VERMONT YANKEE NUCLEAR POWER CORPORATION

**Subject: Vermont Yankee Nuclear Power Station
License No. DPR-28 (Docket No. 50-271)
Technical Specification Proposed Change No. 244
Revised P/T Curves and
Exemption Request to use Code Cases N-588 and N-640**

Proposed Technical Specification Change No. 244

Revised P/T Curves

FIGURE 3.6.2

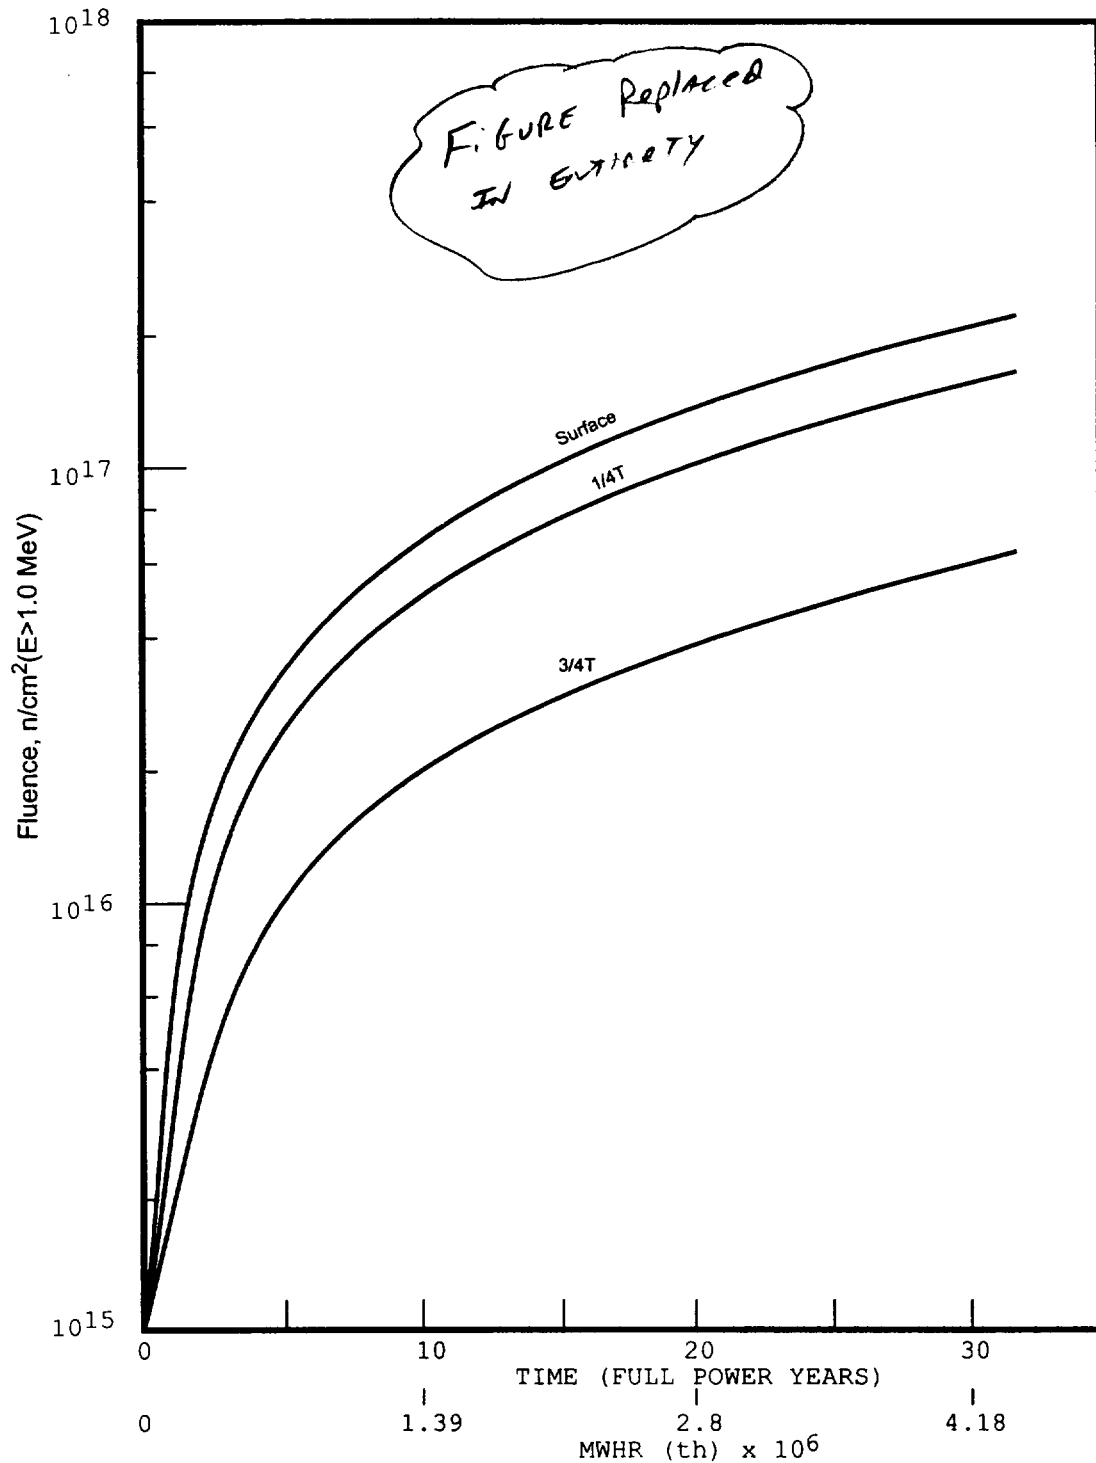
In this proposed change, Technical Specification Figure 3.6.2 "Fast Neutron Fluence ($E > 1$ MEV) as a Function of Thermal Energy and Full Power Years" and Figure 3.6.3 "Fluence Factor for use in Regulator Guide 1.99, Revision 2," have been replaced with the P/T curves for Core Not Critical and Core Critical Operation. The current Figure 3.6.2 provides beltline fluence values at the vessel surface as well at 1/4T and 3/4T as a function of full power years. However, these curves are not utilized in the development of our proposed curves. The proposed P/T limits were calculated utilizing an end of life fluence value. Accordingly, the current Figure 3.6.2 is being replaced. Figure 3.6.3 is a copy of the fluence factor curve from RG 1.99, Rev 2. It has an additional line demonstrating VY's conservatism from our previous submittal (see footnote 1). Since these curves were not utilized in the development of our current P/T limits, the figure is being removed from the specifications.

FIGURE 3.6.3

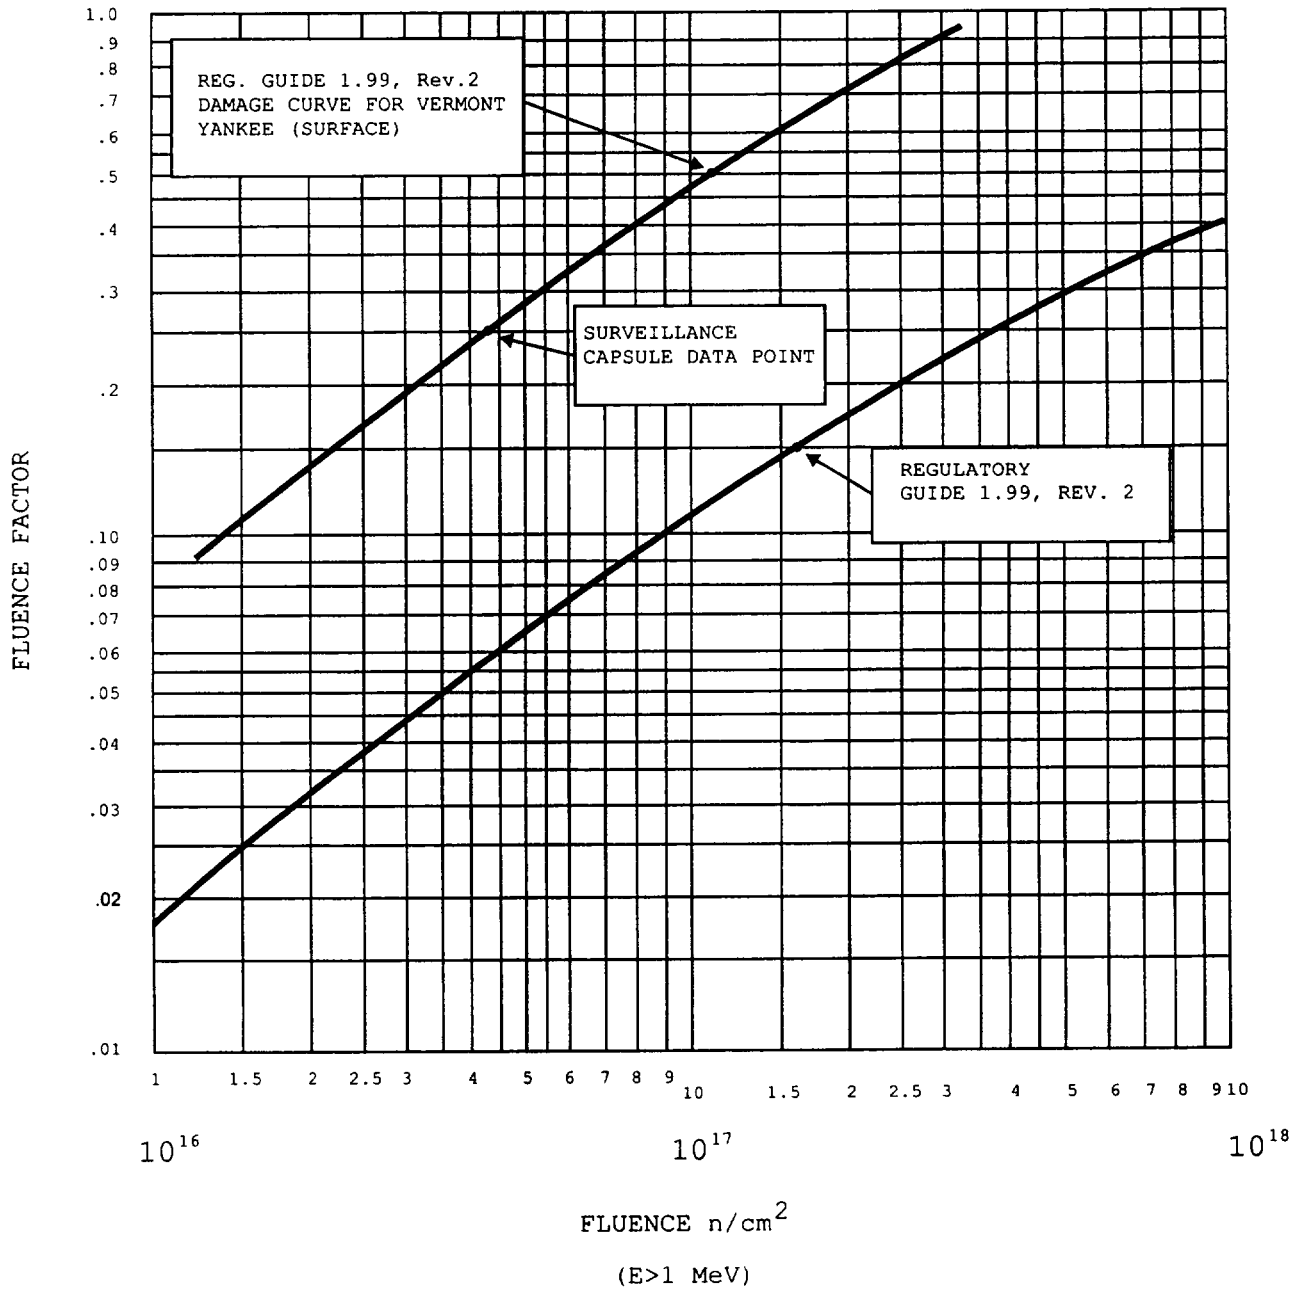
*Figure Replaced
In Entirety*

FIGURE 3.6.1

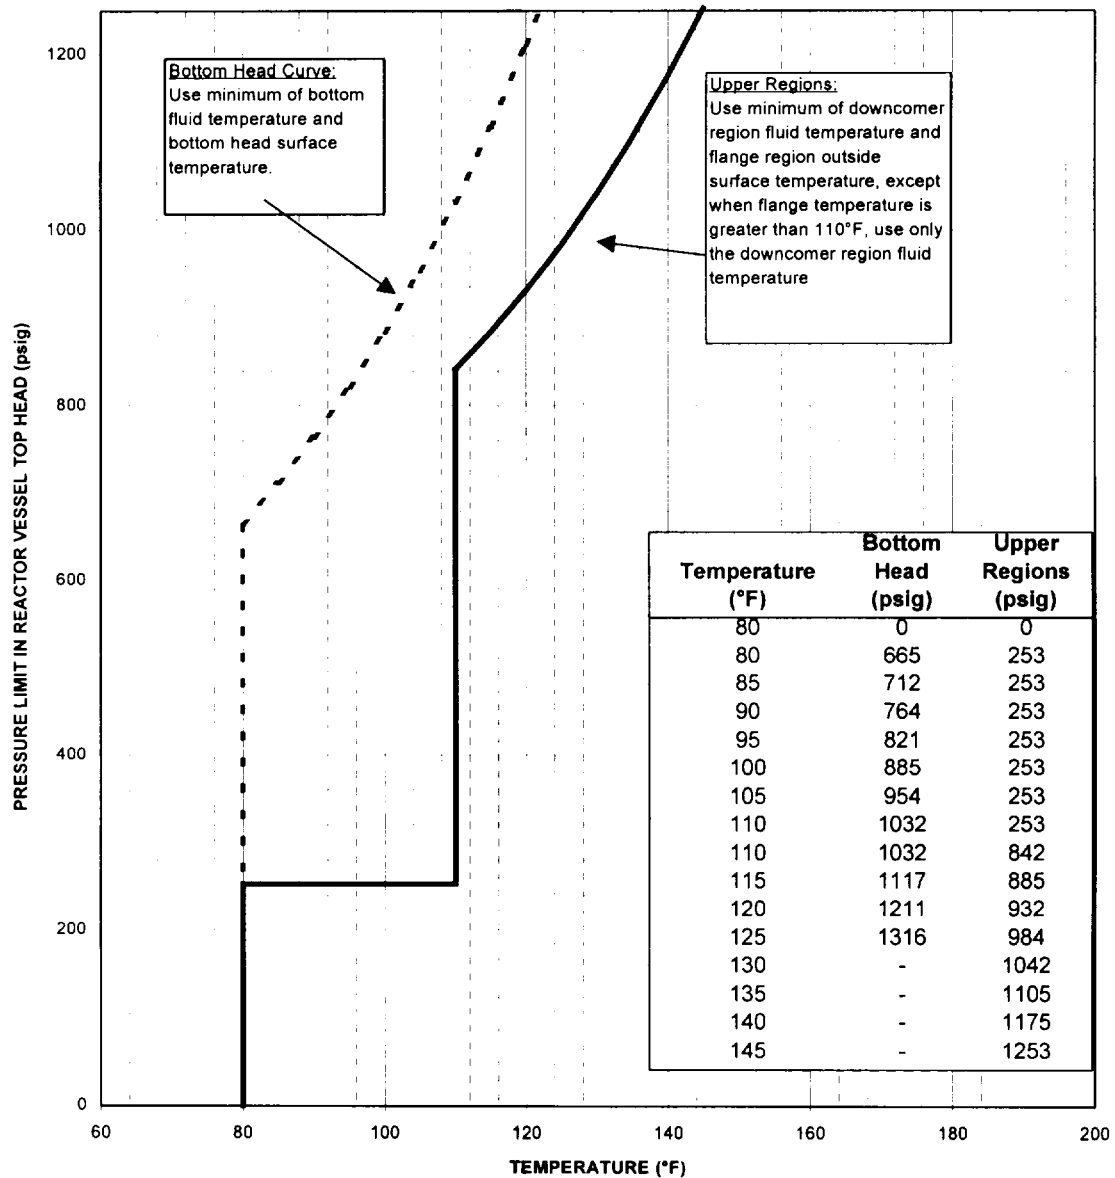
The proposed change would revise the reactor vessel pressure/temperature (P/T) limit curves specified in TS 3.6.A.1, "Reactor Coolant System - Pressure and Temperature Limitations," as graphically represented in Figure 3.6.1, for reactor heatup, cooldown, and critical operation, as well as for inservice hydrostatic and leak tests. Figure 3.6.1 would be replaced with three figures:

- Figure 3.6.1, "Reactor Vessel Pressure-Temperature Limitations: Hydrostatic Pressure and Leak Tests, Core Not Critical,"
- Figure 3.6.2, "Reactor Vessel Pressure-Temperature Limitations: Normal Operation, Core Not Critical," and
- Figure 3.6.3, "Reactor Vessel Pressure-Temperature Limitations: Normal Operation, Core Critical."

The current pressure-temperature limits specified in TS Figure 3.6.1 are represented by several curves on a single figure, for the various operating and/or test conditions. The current curves are to be replaced with recalculated curves on separate figures, and the associated descriptions contained on the figures are to be revised as well. Revised TS Figure 3.6.1 will have a curve for the bottom head region of the vessel and a composite RCS curve (excluding the bottom head) for hydrostatic testing and leak testing conditions for an exposure level equivalent to a gross power generation of 4.46×10^8 MWH(t) (which will bound VY power generation beyond March 21, 2012, the end of VY's current operating license (EOL) and is equivalent to 32 effective full power years (EFPY)). Figure 3.6.2 will have a curve for the bottom head region of the vessel and the composite RCS curve (excluding the bottom head) for non-critical operation for up to 4.46×10^8 MWH(t). Figure 3.6.3 will have a curve for the bottom head region of the vessel and the composite RCS curve (excluding the bottom head) for reactor critical operation for up to 4.46×10^8 MWH(t). These curves for specifying the required temperature limits will continue to ensure margin to the brittle fracture temperature, i.e., the nil ductility temperature (NDT), for the noted operations or conditions. One of the primary effects of the revised curves is to permit reactor vessel inservice hydrostatic and leak tests to be performed at a lower temperature at applicable vessel pressures.

Reactor Vessel Pressure-Temperature Limitations
Hydrostatic Pressure and Leak Tests, Core Not Critical

40°F/hr Heatup/Cooldown Limit
Valid Through 4.46E8 MWH(t)
